**Title:** Park Plaza Walgreens Project (P12-016) [Noticed 08/28/2015; Passed for Publication 09/01/2015; Published 09/04/2015]

**Location:** 1600 – 1620 West El Camino Avenue, District 3

## Description/Analysis

EXTERIOR  
BUILDING  
ELEVATIONS

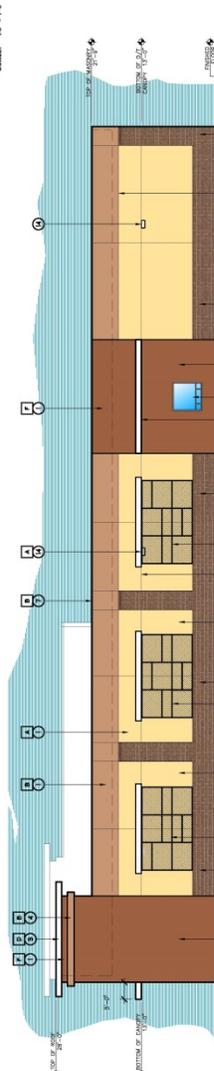
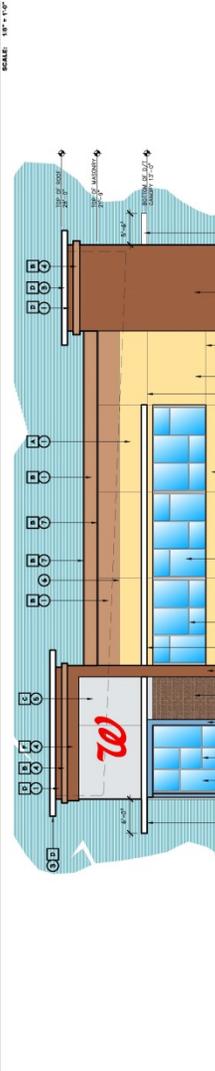
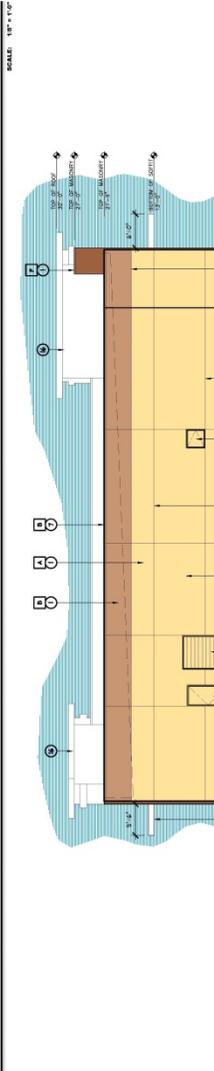
#### **7. Redesign pharmacy building to provide windows on all sides**

The urban form guidelines for the Suburban Center designation in the City of Sacramento General Plan includes "Building facade and entrances directly addressing the street and have a high degree of transparency on street-fronting façade." Buildings with windows providing views of the surrounding public and private spaces increase the sense of safety experienced by pedestrians. The only transparency apparent on the elevation drawings are the front entrance, a segment of the wall on each side of the entrance, and the drive-through service window. Most of the buildings wall spaces do not include windows or doors. About half of the elevation facing the main parking area and almost all of the store fronts in the shopping center is a blank wall. By comparison,

WALKSacramento recommends the exterior elevations for the new building include more windows, articulation, and architectural features to provide an interesting appearance that blends with the surrounding buildings.

- 7) Staff has worked with the applicant to provide an aesthetically pleasing design for the building that is consistent with the overall shopping center; wall trellising and wainscoting are incorporated into the design to enhance elevations where windows cannot be incorporated;

# Exhibit E: Existing Tree Preservation and Removal Plan

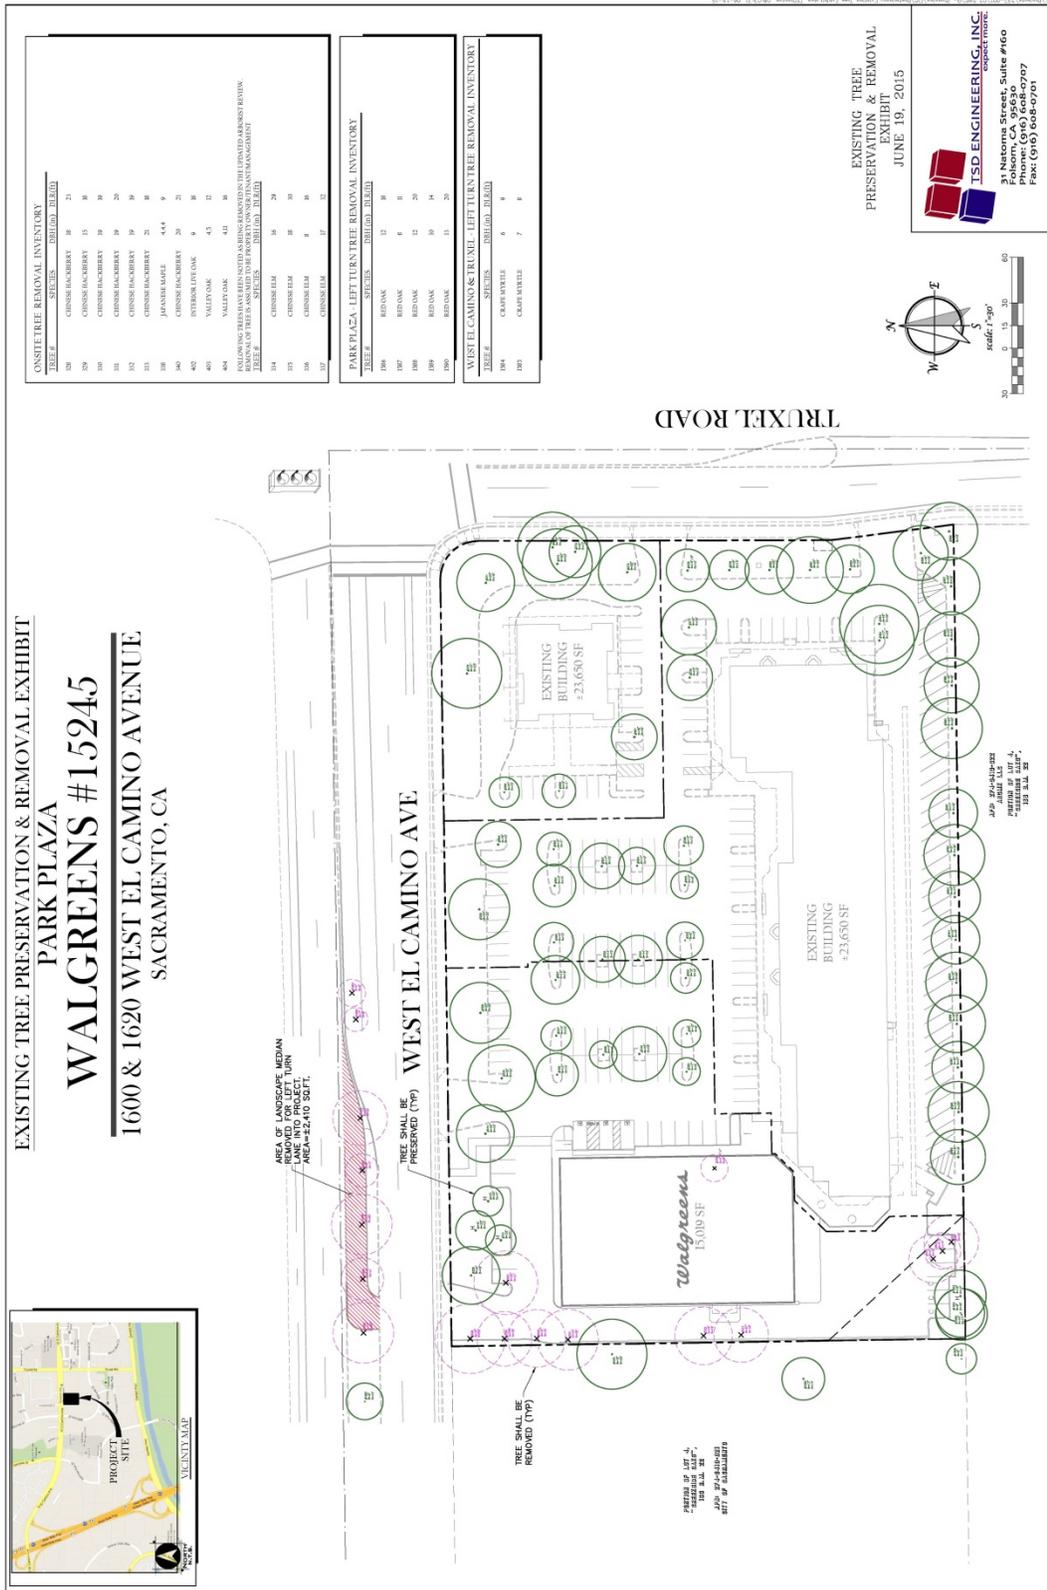
The preliminary site plan drawing appears to show that 14 existing shade trees and two ornamental trees will be removed. The areas affected include

- The area between the sidewalk and the building will lose six trees. The preliminary site plan has two of the existing tree centers marked as parking lot lights and two marked "demo tree" and the tree canopy outlines for four trees are shown, so it's difficult to know which trees, if any, will remain.

- The landscape planter along the west fence will lose six shade trees because the existing 10-foot-wide landscaping strip is reduced to a width of 4 feet and the trees are where the widened driveway is proposed.

- Three of the four shade trees in the plaza to the south of the existing building will be removed. The one tree remaining is the only tree marked on the preliminary site plan as "Ex. tree shall to be protected".

- Two ornamentals in existing planters on the building's east frontage walkway appear to be removed.
- Five trees in the median will be removed to make room for the left turn lane that is proposed to provide direct access for west-bound traffic.

This project will remove too many trees with no plans to replace them. For the health and enjoyment of South Natomas residents, WALKSacramento recommends the site plan be revised to retain all existing trees on site.

- 2) The removal of trees on-site and off-site is discussed under the Site Plan and Design Review, Landscaping section later in the report. The applicant is planting new trees on-site within the parking area and has initiated discussion with Public Works regarding replacing street trees in a new median to be constructed east of the projects site on West El Camino. The project is conditioned that “replacement shall be accommodated within the public right-of-way in the form of a median. If the Urban Forestry Division determines that a median is not feasible, replacement trees may be planted at another off-site location at the City’s direction”;

Exhibit L: Proposed Median Addition

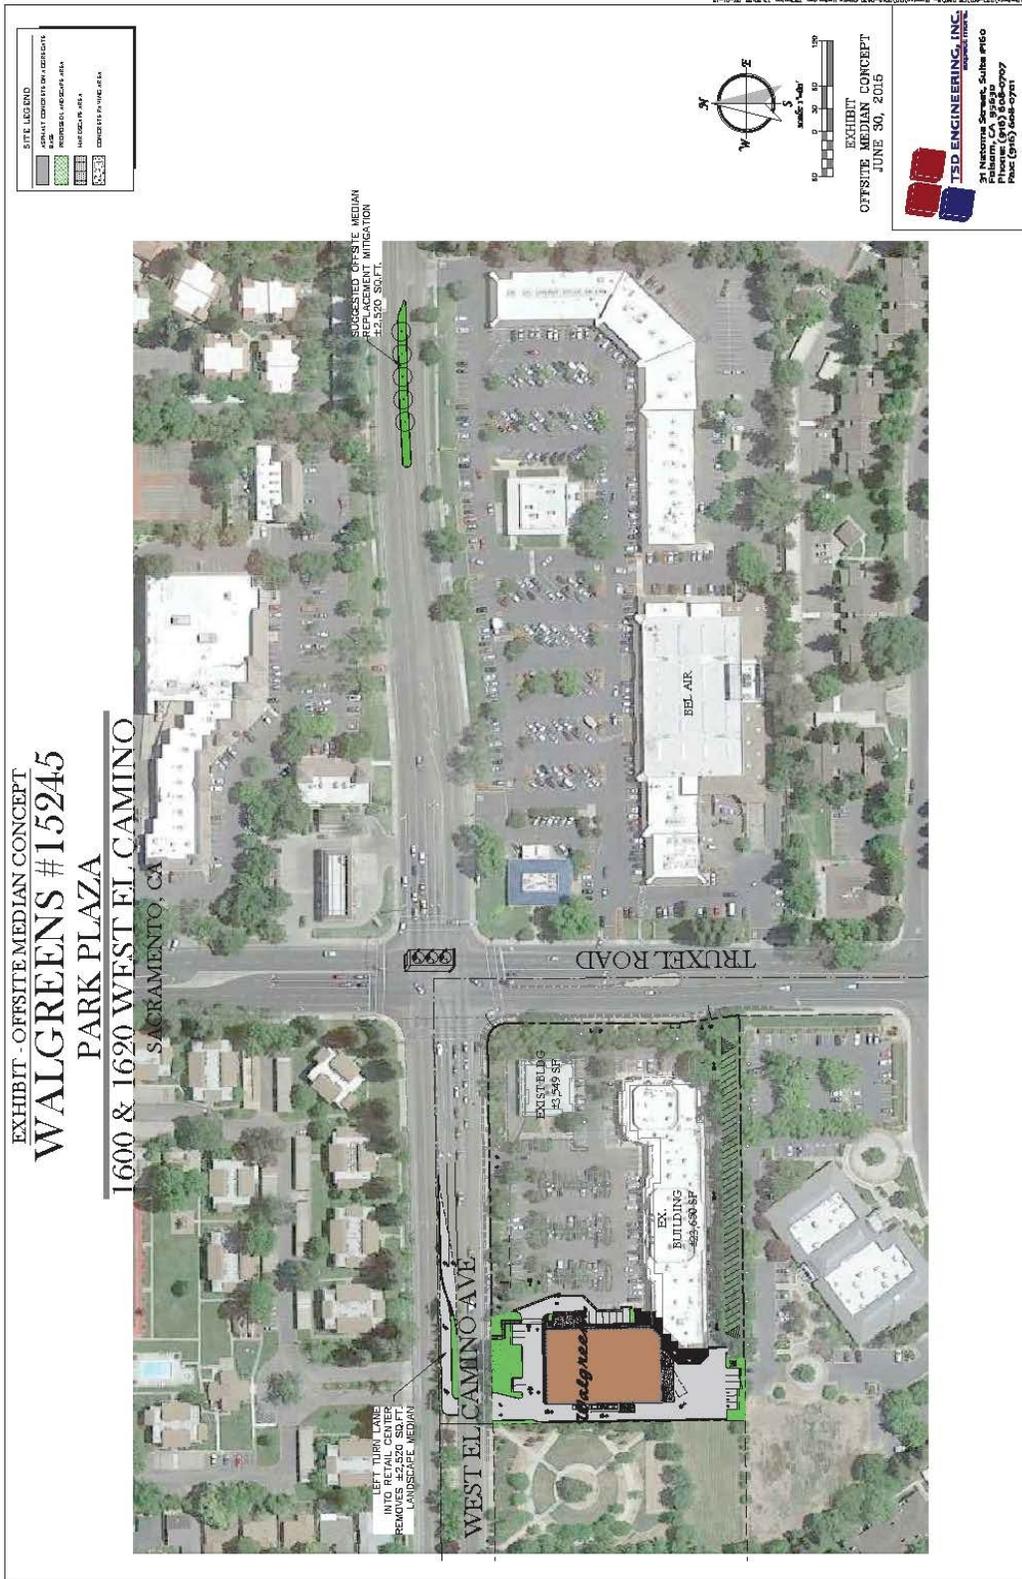
### **3. Remove the median left turn lane from the project**

The area surrounding the project site, although classified as "suburban", has a number of high-density residential and commercial land uses. The area needs more features to accommodate pedestrian travel, such as street crossings, instead of auto-oriented designs and street modifications. The left turn lane proposed for the West El Camino median will encourage more car trips to the site and expose pedestrians to more vehicle conflicts at the driveway.

ROCA has to stop short of endorsing this project as proposed, however, because the applicant still plans to move forward with the uncontrolled left turn lane and corresponding removal of seven mature shade trees in order to support its drive-through pharmacy. This proposal is inconsistent with the South Natomas Community Plan, which specifies that the City shall discourage drive-through commercial uses. Not only will this turn lane be costly for the applicant and disruptive to residents, it will not provide significantly better access, since a signaled u-turn exists less than a block away.

- 3) The applicant has stated that the left-turn lane is a required component for the project in order to provide adequate access to the shopping center. Public Works staff has reviewed the location and development standards and conditioned the turn-lane accordingly;

As the replacement for the removal of City street trees in the center median, the applicant has submitted a possible new center median addition to the east of the site (Exhibit L of Attachment 8) and the project has been conditioned that “replacement shall be accommodated within the public right-of-way in the form of a median. If the Urban Forestry Division determines that a median is not feasible, replacement trees may be planted at another off-site location at the City’s direction”. Also, at the modified center median, five new size-appropriate trees are being planted at the left-turn pocket (Exhibit G of Attachment 8).
